City of Mississauga Department Comments

Date Finalized: 2024-05-22 File(s): A227.24 Ward: 6

Property Address: 3450 Semenyk Court

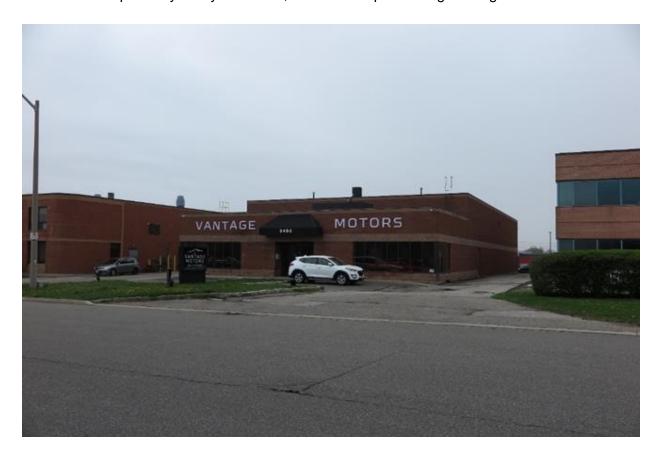
The sole variance requests a reduced aisle width. The intent of this regulation is to ensure there is sufficient space for vehicles to access and exit parking stalls and allow for appropriate vehicular circulation within the subject property. Planning staff note Zoning staff is requesting confirmation on whether the south side aisle width is a one-way aisle. Through conversations with the applicant, they have confirmed the south side aisle width is to be utilized as a one-way aisle. Staff are satisfied that the reduced drive aisle allows sufficient space for vehicles to access and exit parking stalls and appropriate vehicular circulation can be maintained. Additionally, Planning staff have confirmed with the City of Mississauga's Legal Department that there are no mutual access easement rights concerning the shared driveways for the adjacent properties (3440 Semenyk Court to the south and 3464 Semenyk Court to the north).

Staff are satisfied that the proposal maintains the general intent and purpose of both the official plan and zoning by-law, is minor in nature and represents appropriate development of the subject property.
